ADDENDUM NO. 1

LUCCHESI TURF FIELD REPLACEMENT PROJECT City Project Number C14502008

March 8, 2023

DRAWN BY KL	CHECKED BY WD/DC
DATE ISSUED 02/17/23	SCALE 1"=20'-0"
PROJ. NO. 2108300	
SHEET NO. L3.0

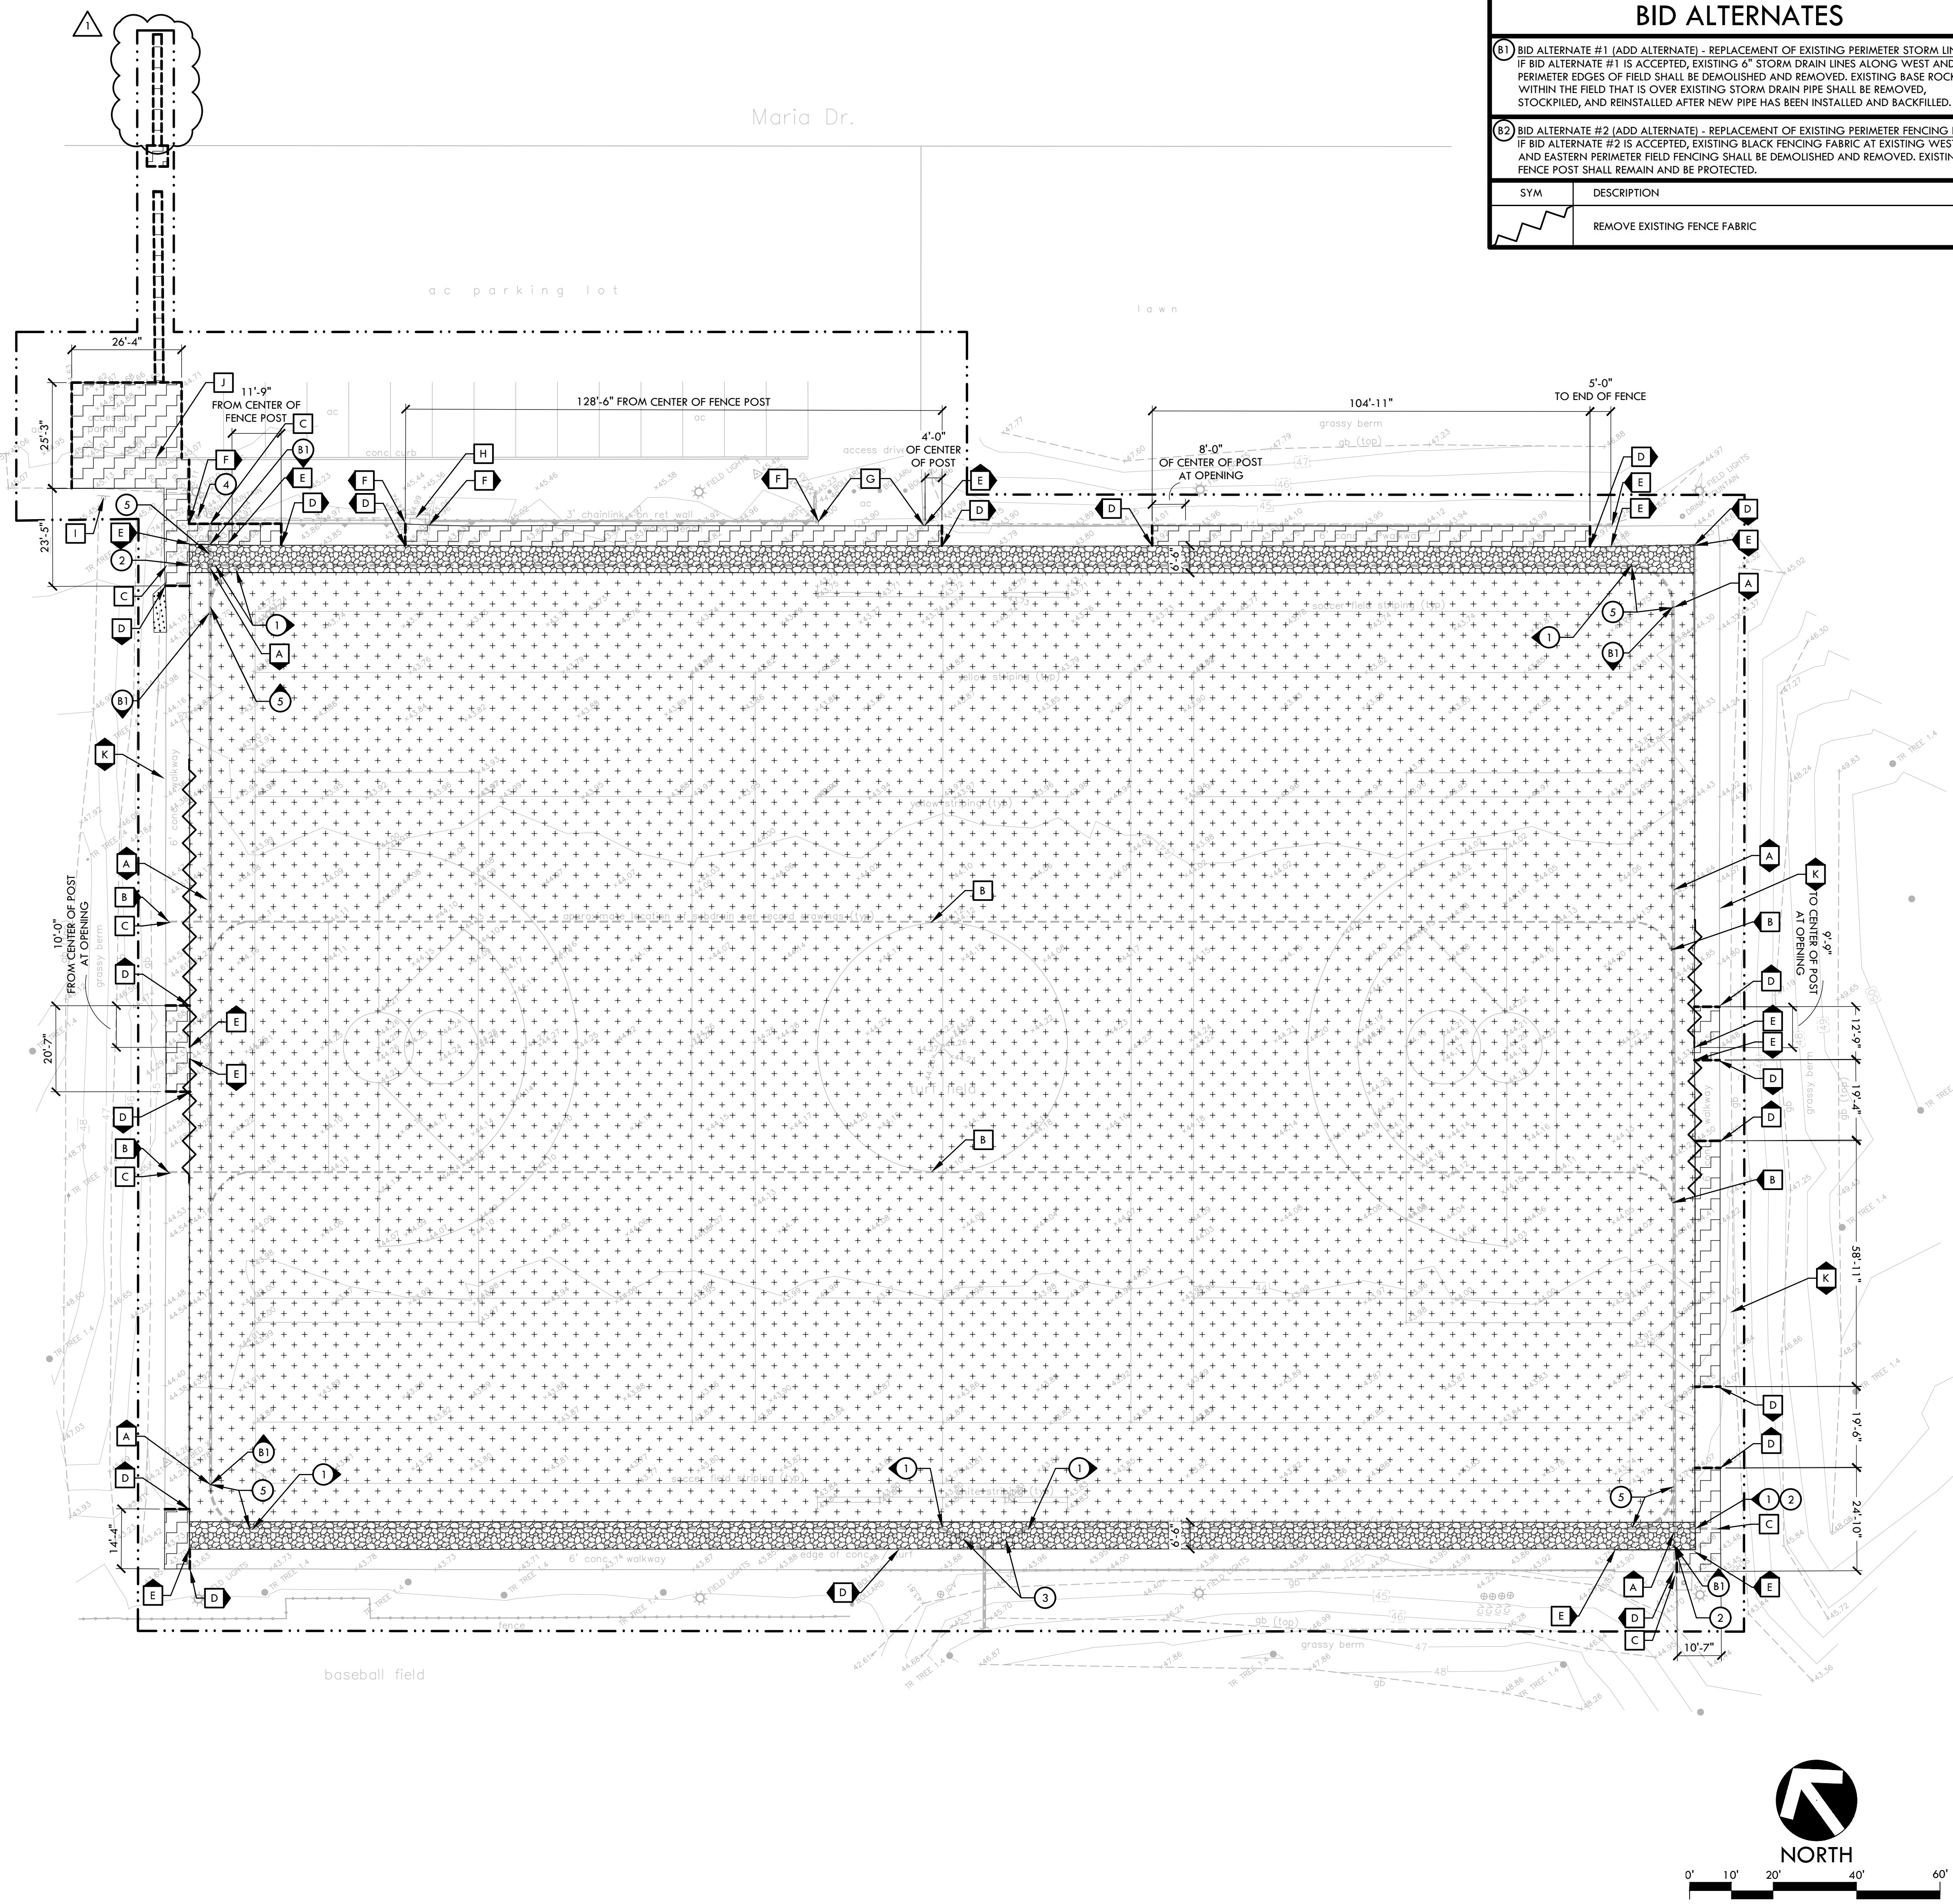
1. Drawing Sheet L3.0 was **revised** and **posted** in the City website.
Revised L3.0 shall be incorporated in the bid documents. Revision includes additional sawcutting and hardscape demolition within the Maria Dr to show the full length of demolition to tap into the existing water mainline.

DRAWN BY: **KL** CHECKED BY: **WD/DC**
 DATE ISSUED: **02/17/23** SCALE: **1"=20'-0"**
 PROJ. NO.: **2108300**
 SHEET NO.: **L4.0**

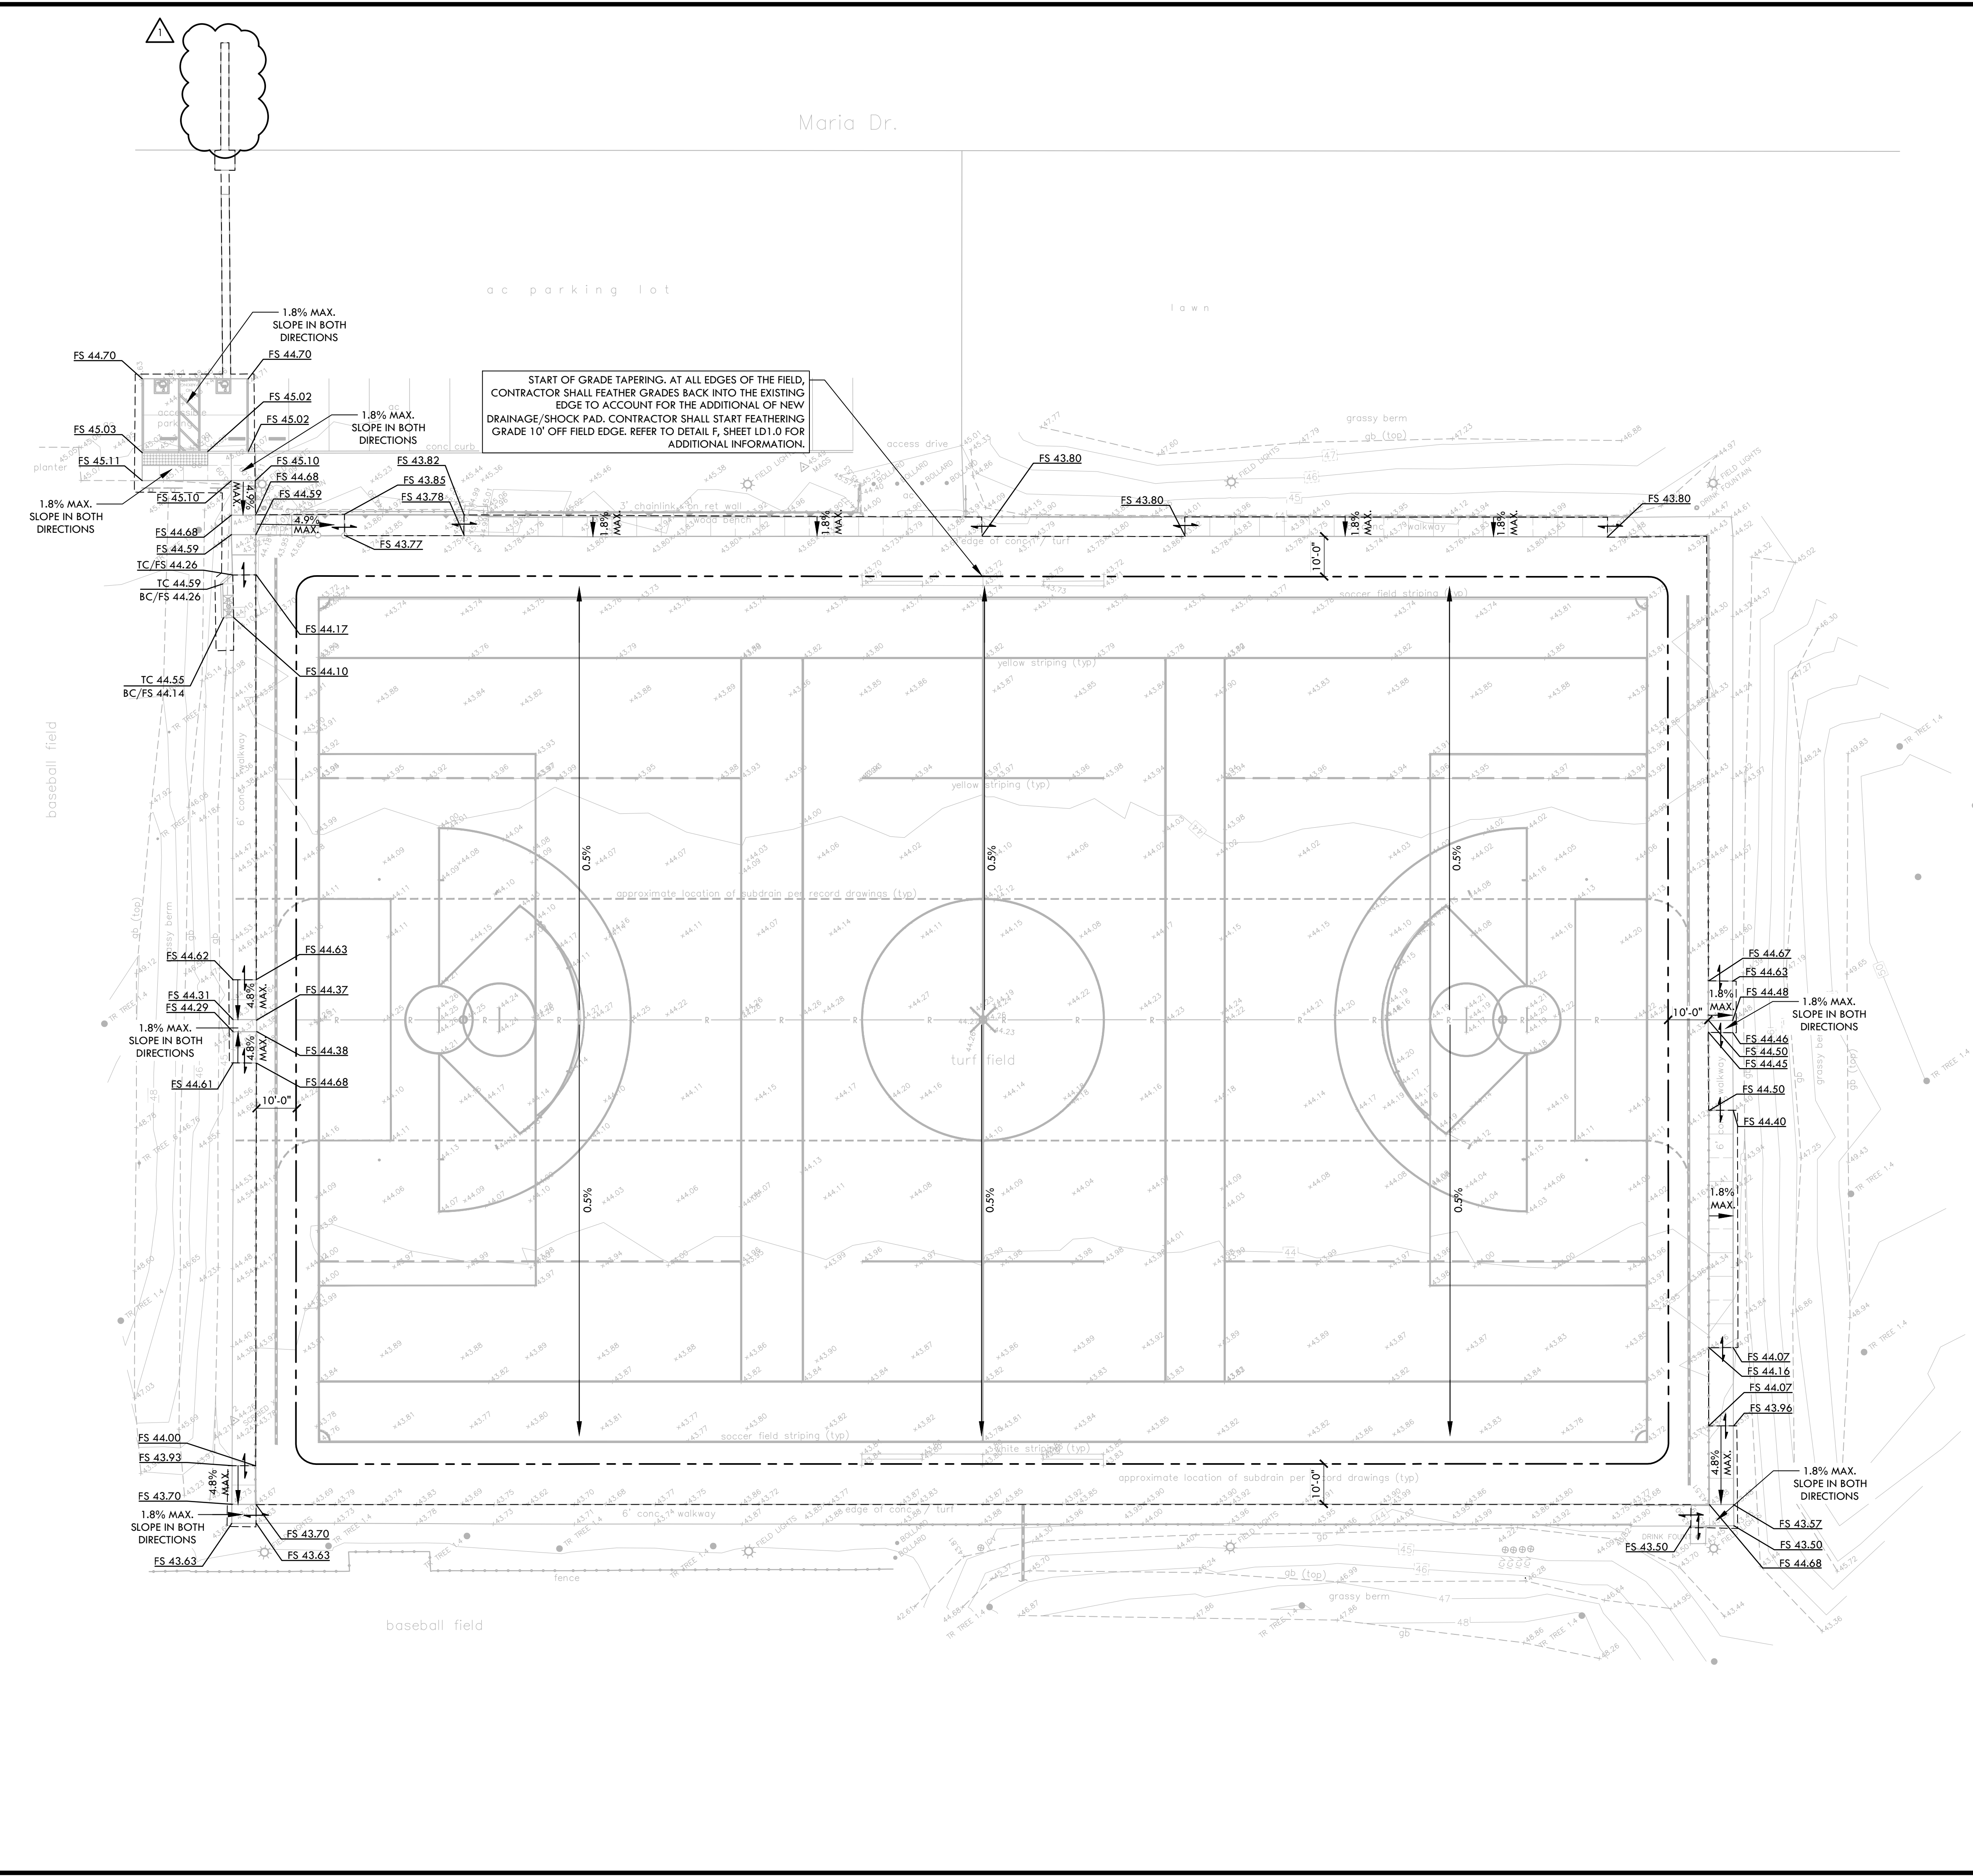
2. Drawing Sheet L4.0 was **revised** and **posted** in the City website.
Revised L4.0 shall be incorporated in the bid documents. The revision includes modification to the limits of grading in Maria Dr.

SHEET NO. **L5.0**

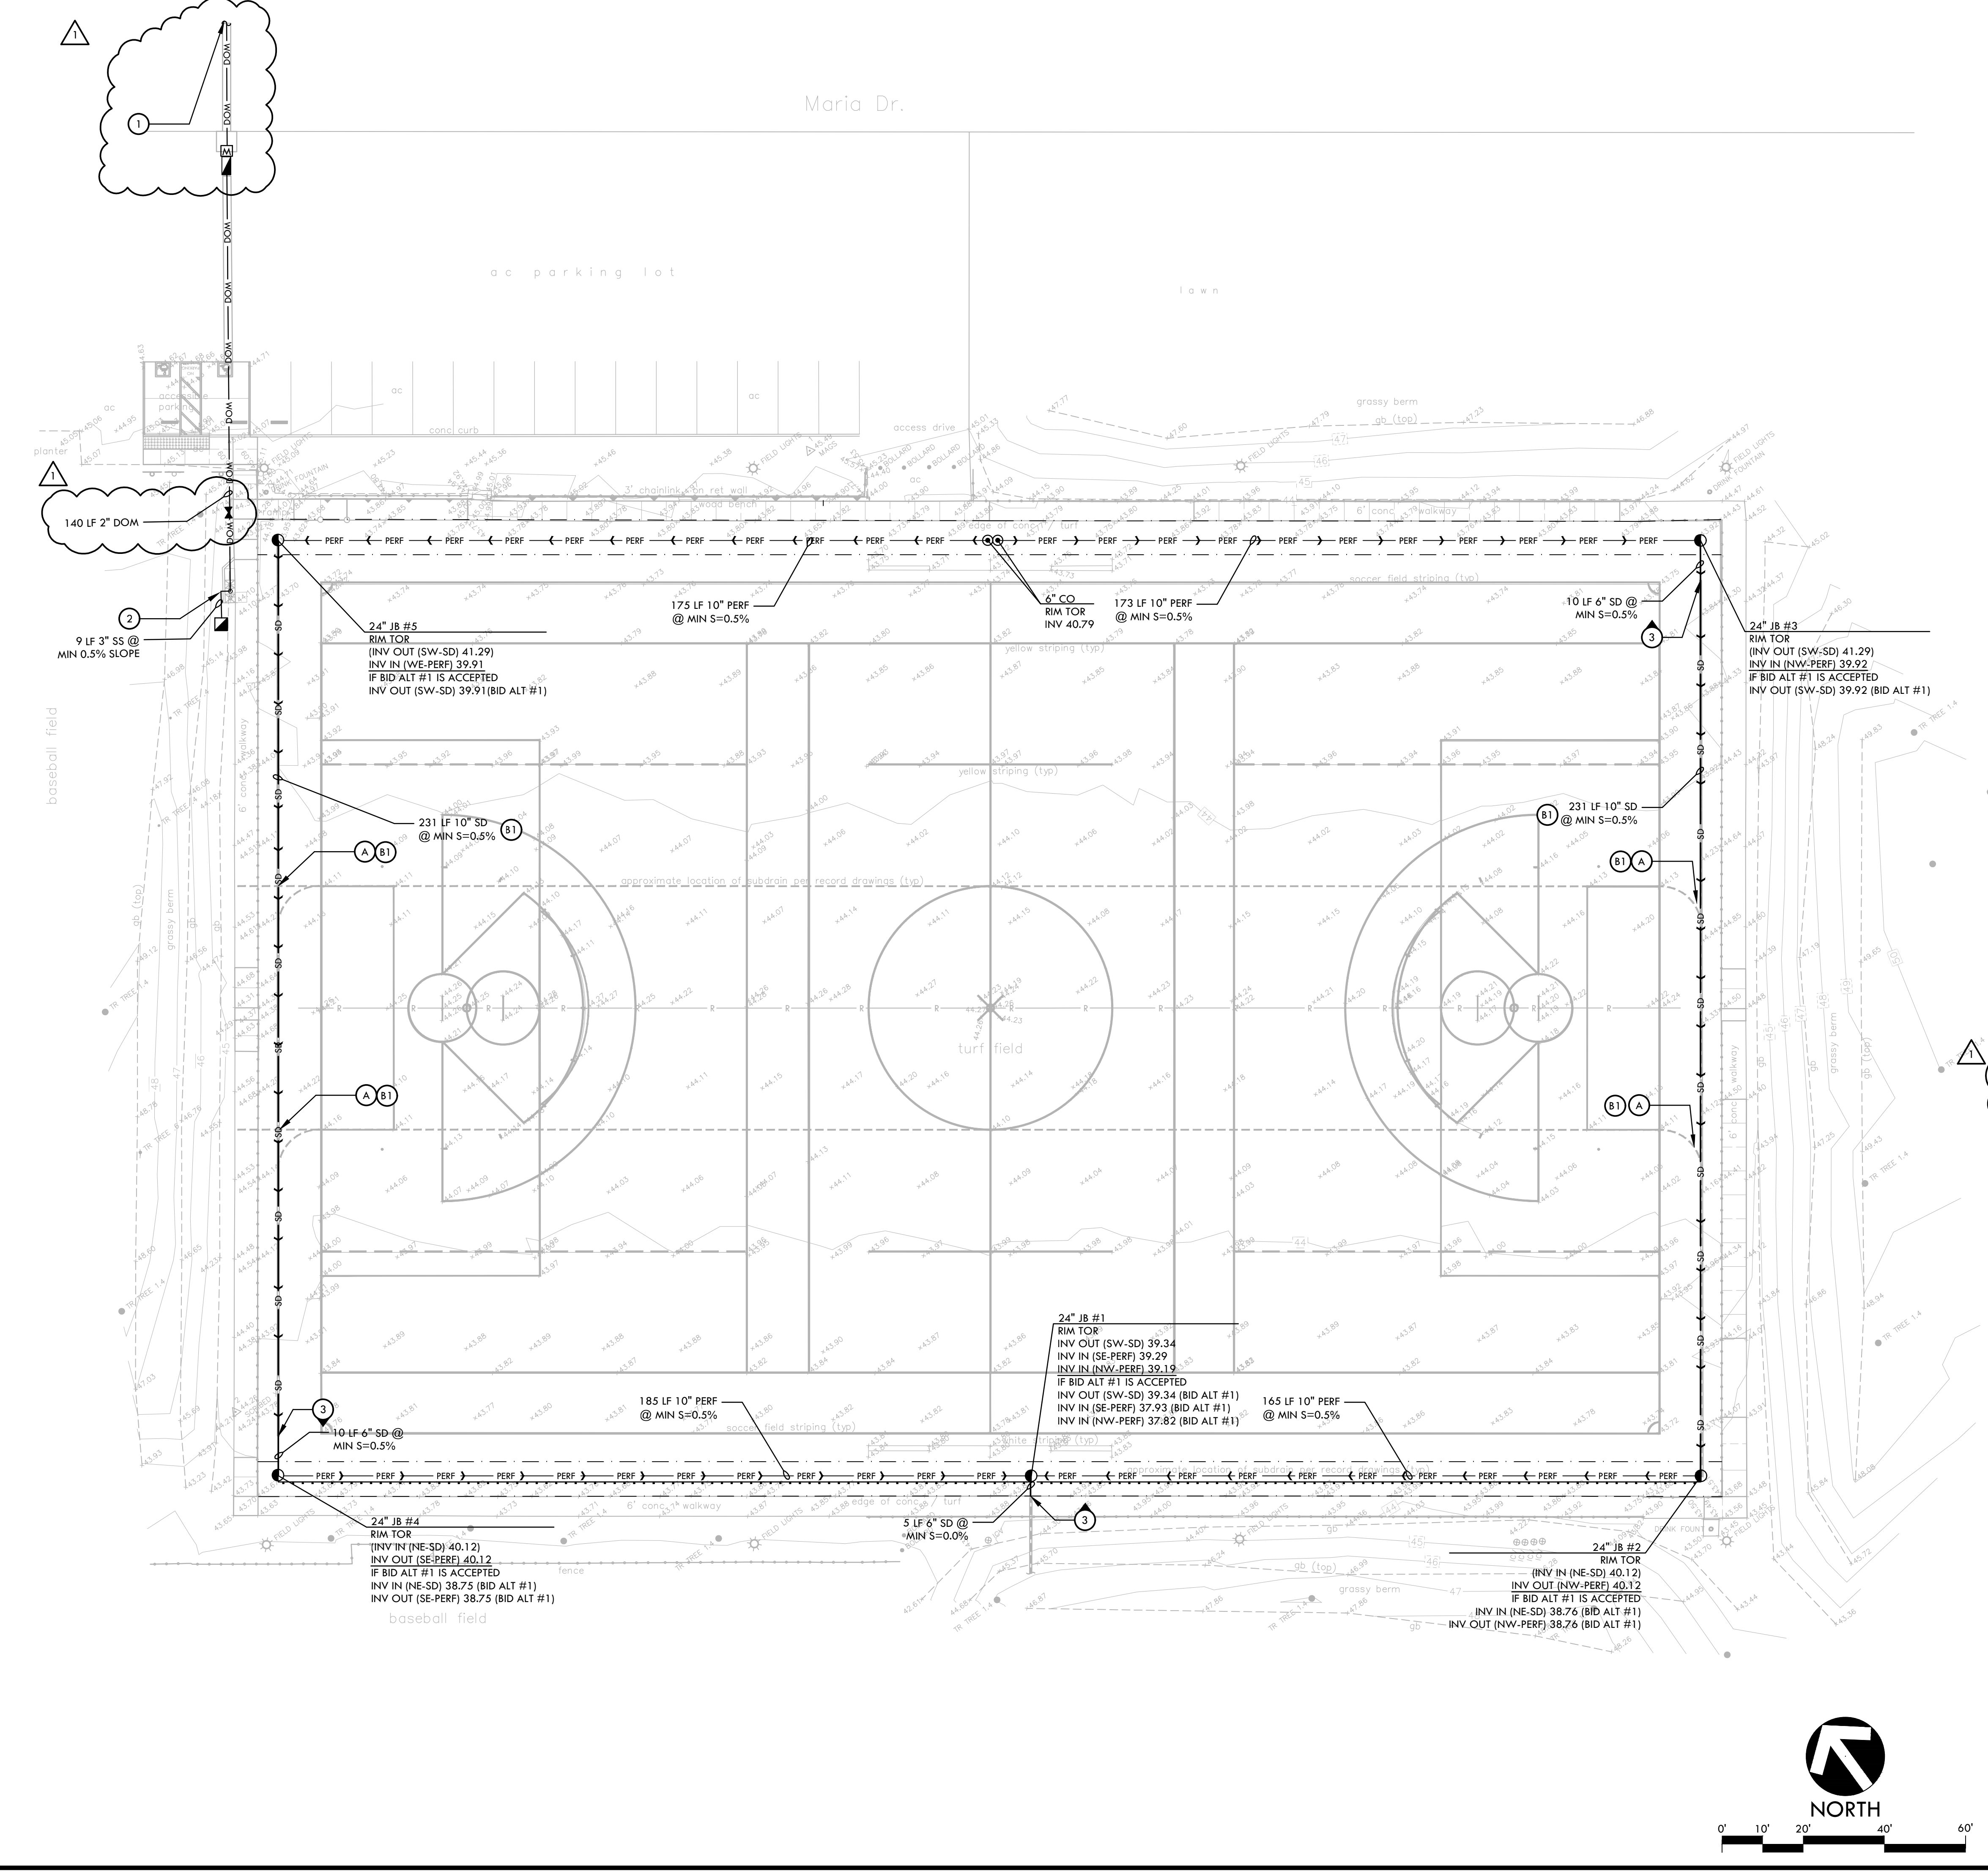
3. Drawing Sheet L5.0 was **revised** and **posted** in the City website.
Revised L5.0 shall be incorporated in the bid documents. Revisions include modification to the length of the new domestic water line that will connect to the existing water line in Maria Dr. Modification also includes adding the existing mainline size of 10" to callout #1 within the legend.

NO.	DESCRIPTION
1	CONTRACTOR SHALL TIE IN NEW DOMESTIC WATER LINE INTO EXISTING 10" MAINLINE IN MARIA DRIVE. CONTRACTOR SHALL POTHOLE TO VERIFY ON SITE LOCATION OF EXISTING WATER LINE. CONTRACTOR SHALL REFER TO THE CITY OF PETALUMA WATER STANDARDS FOR MAINLINE CONNECTION PROCEDURES.
2	CONTRACTOR SHALL TIE IN NEW DOMESTIC WATER AND SANITARY SEWER LINE INTO DRINKING FOUNTAIN.
3	CONTRACTOR TO CONNECT NEW SD LINE TO EXISTING 6" SD LINE AT LOCATION SHOWN.
INV	INVERT
EXISTING INV	EXISTING INVERT
RIM	RIM ELEVATION
TOR	TOP OF ROCK ELEVATION
LF	LINEAR FEET
S=0.5%	SLOPE
MIN.	MINIMUM
N, S, W, EA,	NORTH, SOUTH, WEST, EAST
ROOT BARRIER (360 LF)
